## HISTORIC AND DESIGN REVIEW COMMISSION

**HDRC CASE NO:** 2024-427  
**ADDRESS:** 214 ADAMS ST  
**LEGAL DESCRIPTION:** NCB 943 BLK 1 LOT 12  
**ZONING:** RM-4, H  
**CITY COUNCIL DIST.:** 1  
**DISTRICT:** King William Historic District  
**APPLICANT:** Jaime Jimenez/Idea Studio  
**OWNER:** Maher Saloum/SALOUM MAHER  
**TYPE OF WORK:** Conceptual review of a 2-story rear addition and 2-story rear accessory structure construction  
**APPLICATION RECEIVED:** December 18, 2024  
**60-DAY REVIEW:** February 16, 2025  
**CASE MANAGER:** Bryan Morales

### REQUEST:

A2.1

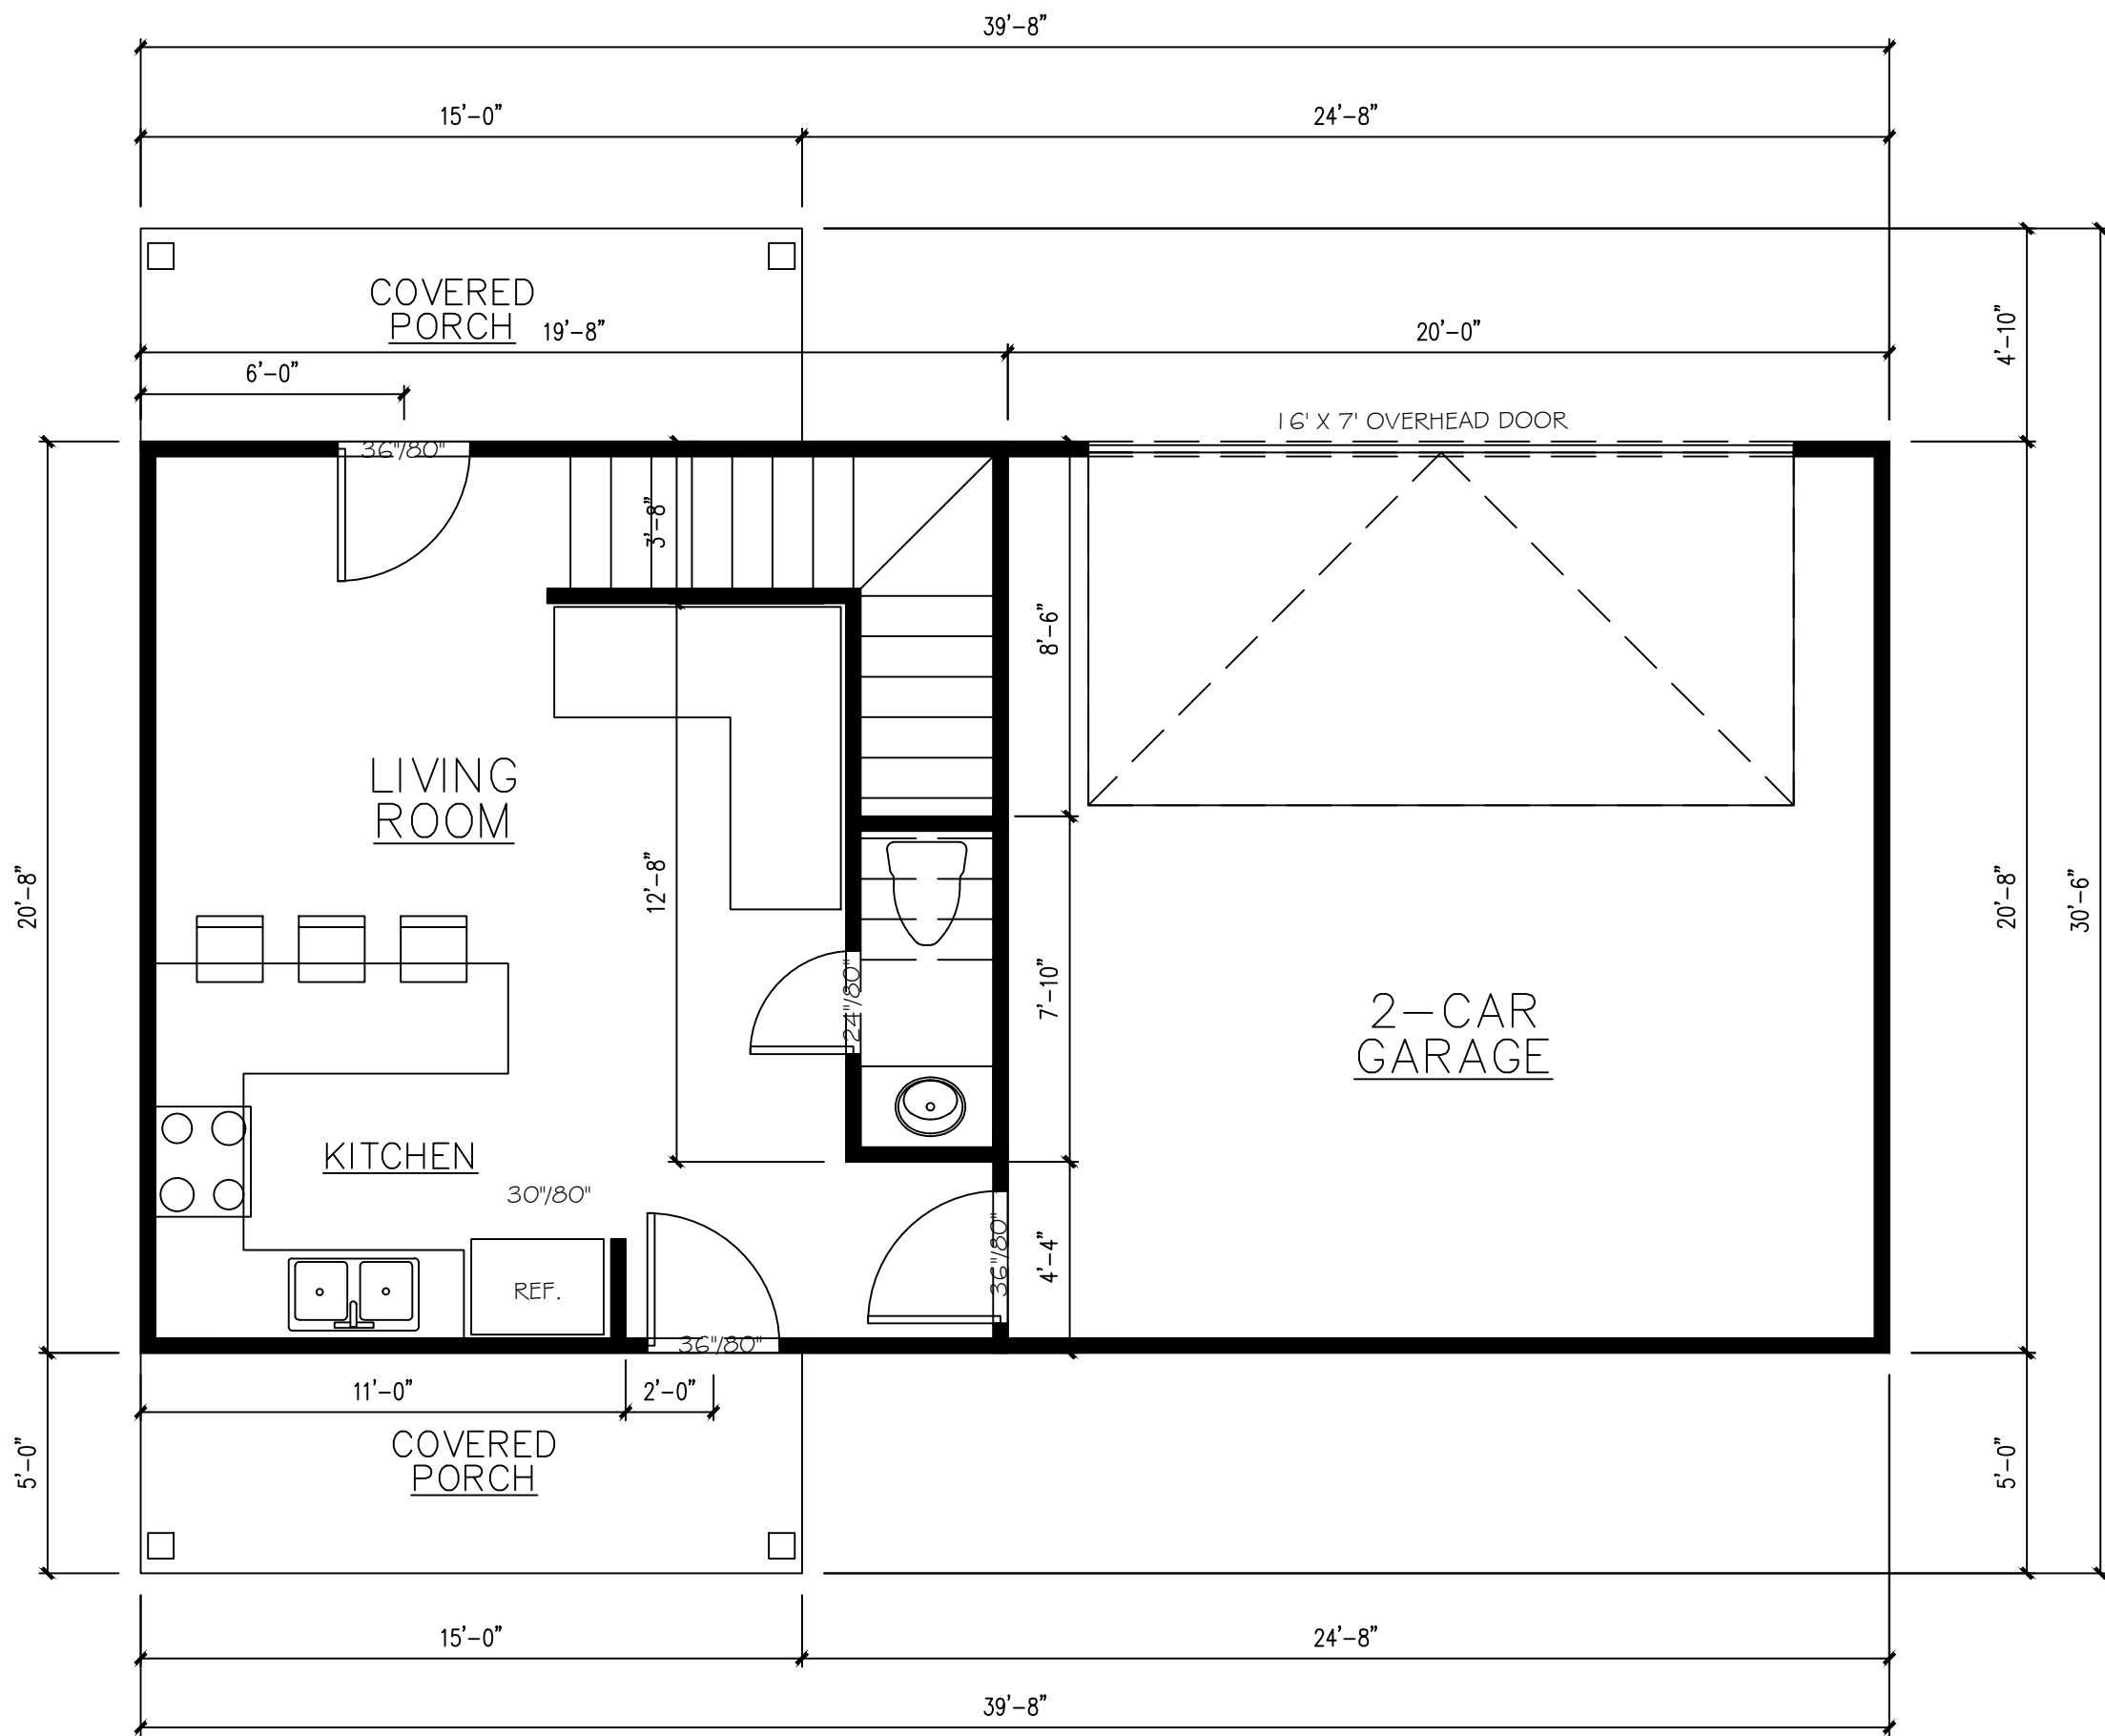
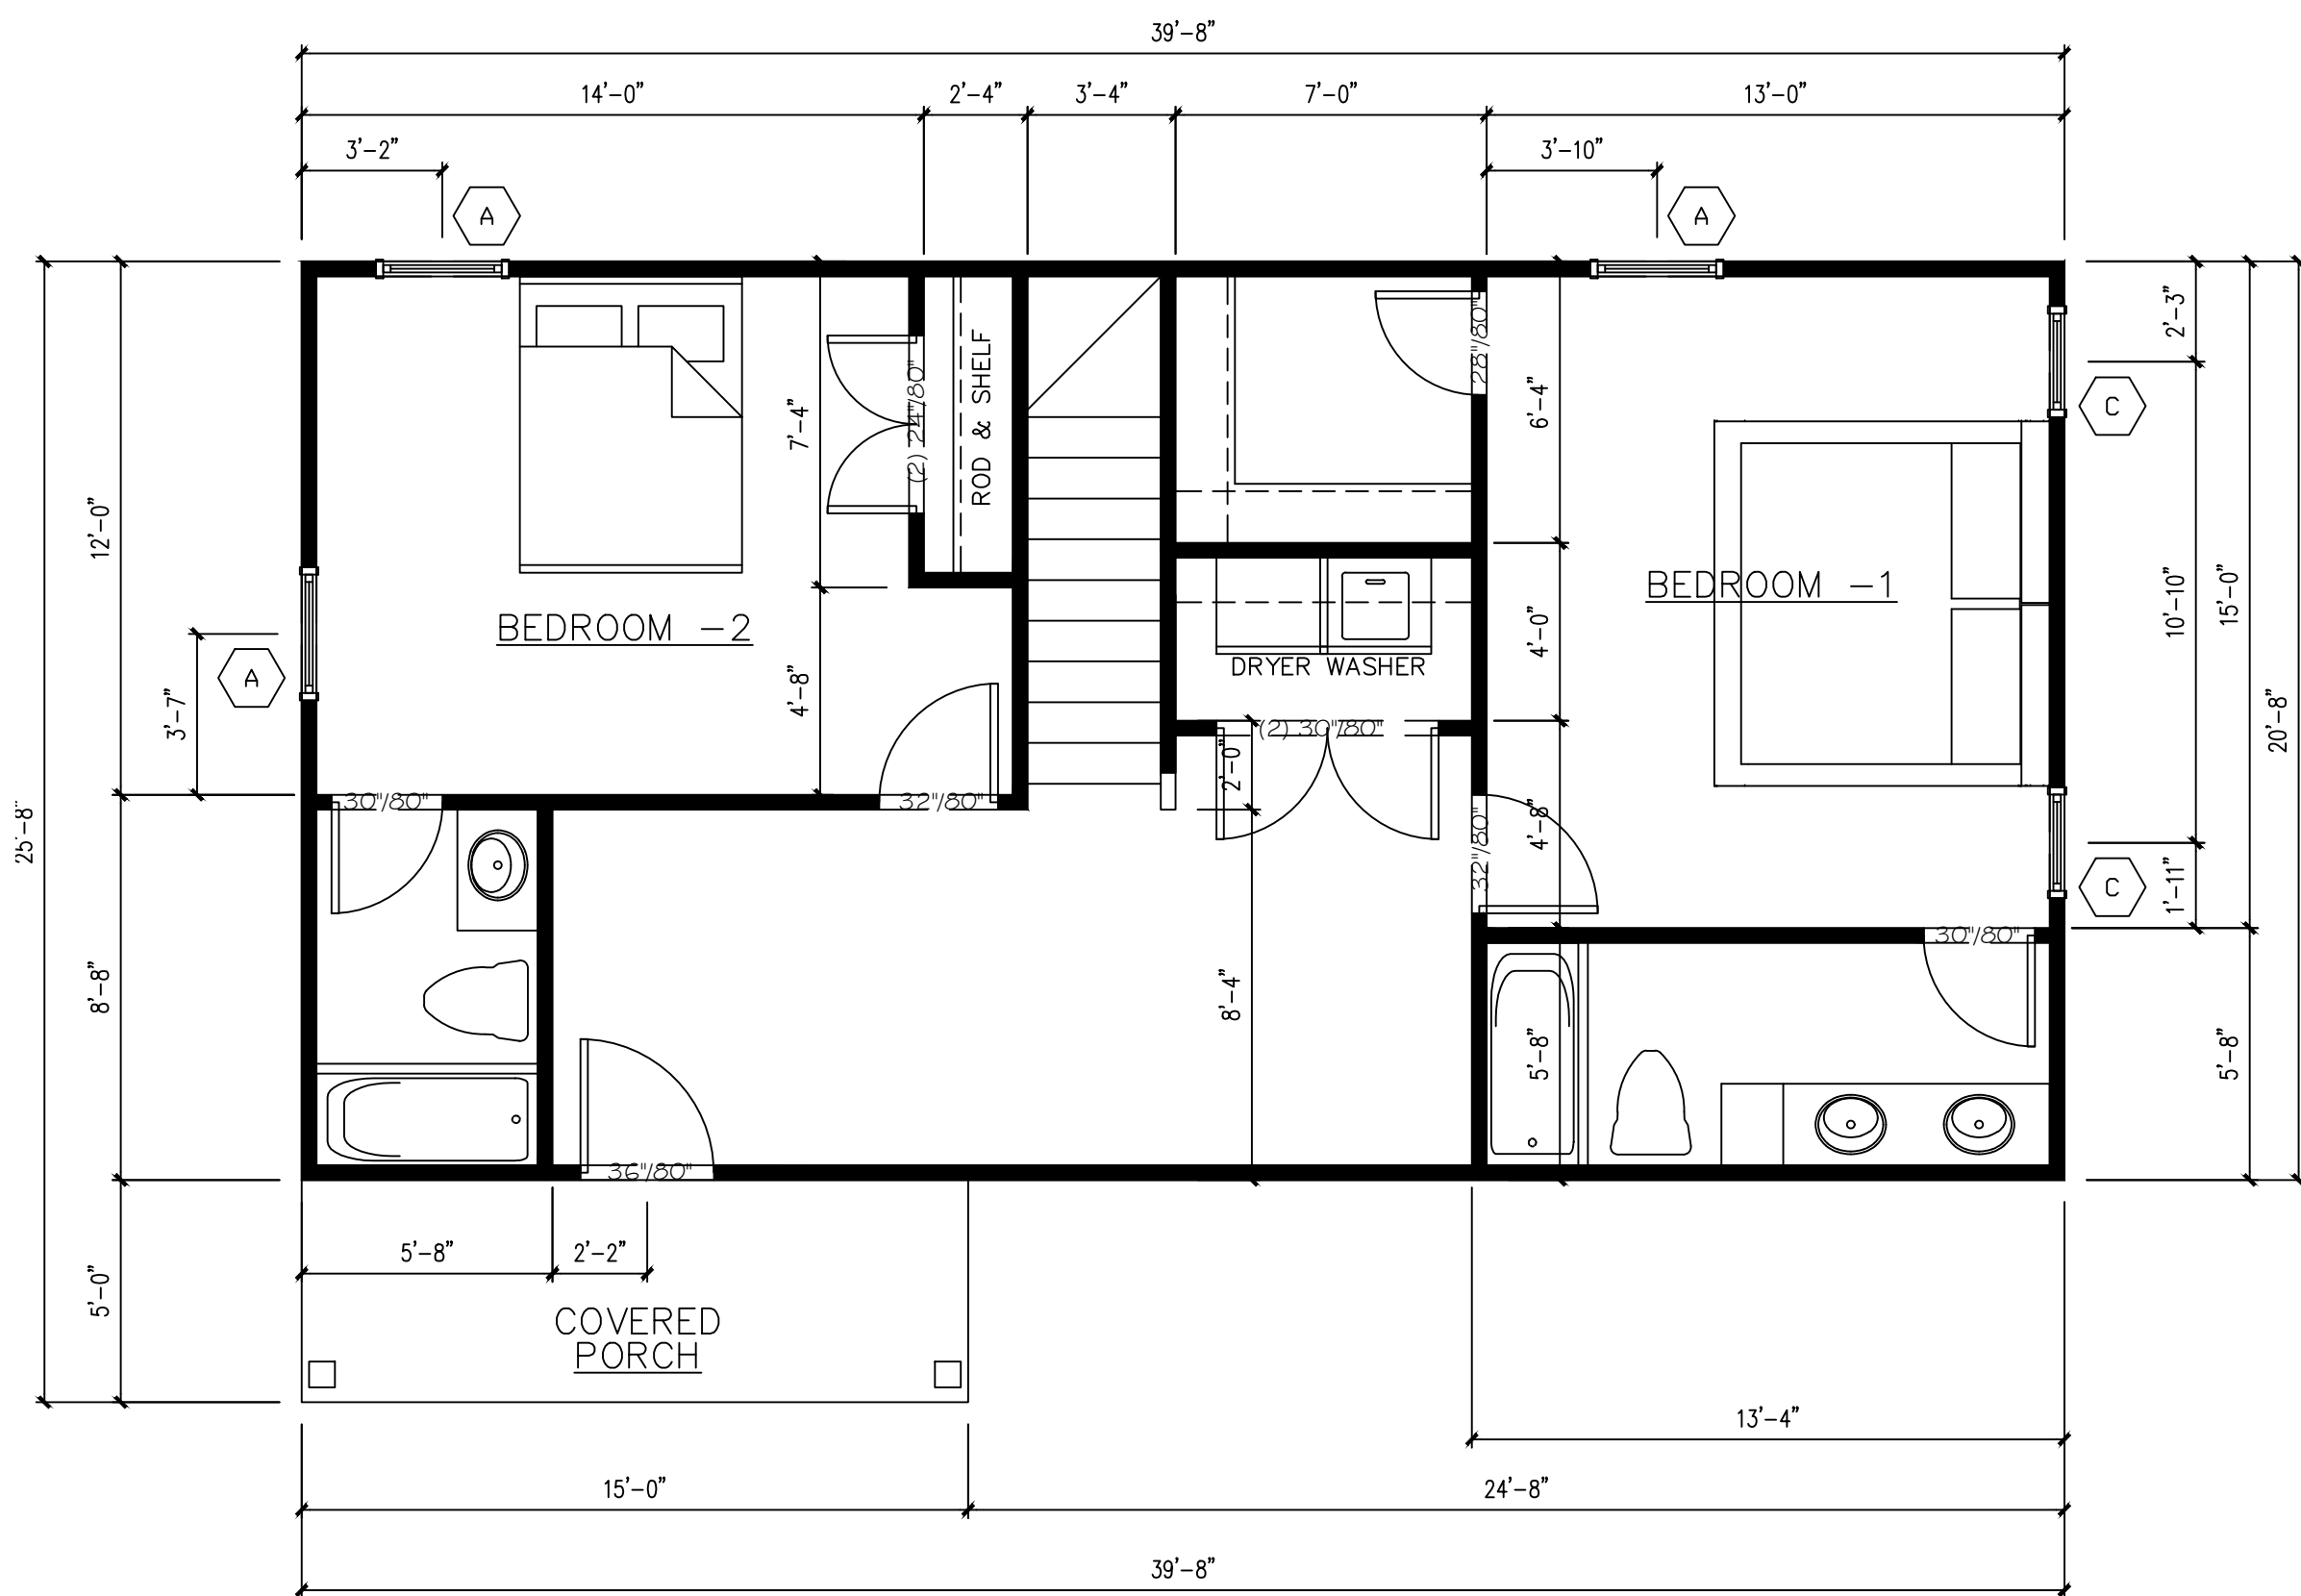
- s. NEW CONSTRUCTION (REAR ACCESORY STRUCTURE) – The applicant is requesting conceptual approval to construct an approximately 1,640 sf 2-story accessory structure at the rear of the property. The Guidelines for New Construction 5.A. notes that new outbuildings should be visually subordinate to the primary historic structure in terms of their height, massing, and form, and should be no larger in plan than forty percent of the primary historic structure’s footprint. The existing primary structure on the lot features a footprint of approximately 2,025 square feet and one story in height. The proposed 2-story accessory structure features a total footprint of approximately 820 square feet, or approximately 40% of the primary structure’s footprint. Accessory structures on the block are predominately 1-story and 2-stories in height. Staff finds the proposed height and general massing does not conform to Guidelines.

- v. ARCHITECTURAL DETAILS – The applicant is requesting conceptual approval to construct a 2-story accessory structure at the rear of the property featuring a 16x7’ garage door, one-over-one windows, an alley-facing porch, and

- a southwest-facing 2-story balcony. The Guidelines for New Construction 5.A.iii. and 5.A.iv. note that new accessory structures should relate to the period of construction of the primary historic structure on the lot by using complementary materials and simplified architectural details. Staff finds the proposed architectural details generally appropriate; however, the garage should feature divided bays and the overall height should be reduced to 1-story.

- x. ARCHITECTURAL DETAILS (FENESTRATION PATTERN) – The applicant is requesting conceptual approval to install one door and two one-over-one windows, and one garage door on the front façade; two doors on the rear façade; two one-over-one windows on the left façade; and one one-over-one window on the right façade. The Guidelines for New Construction 2.C.i. related to window and door openings stipulates to incorporate window and door openings with a similar proportion of wall to window space as typical with nearby historic facades. Staff finds the proposed fenestration pattern generally appropriate; however, the applicant should incorporate additional window openings featuring historic proportions on the left façade’s first floor, the rear façade, and the right façade’s first floor.

Item 2: Staff does not recommend conceptual approval of the 2-story rear accessory structure construction based on the findings. Staff recommends the applicant reduce the height of the proposed rear accessory structure to be subordinate to the primary structure onsite and incorporate staff’s suggestions noted in findings q through y before returning for final review.
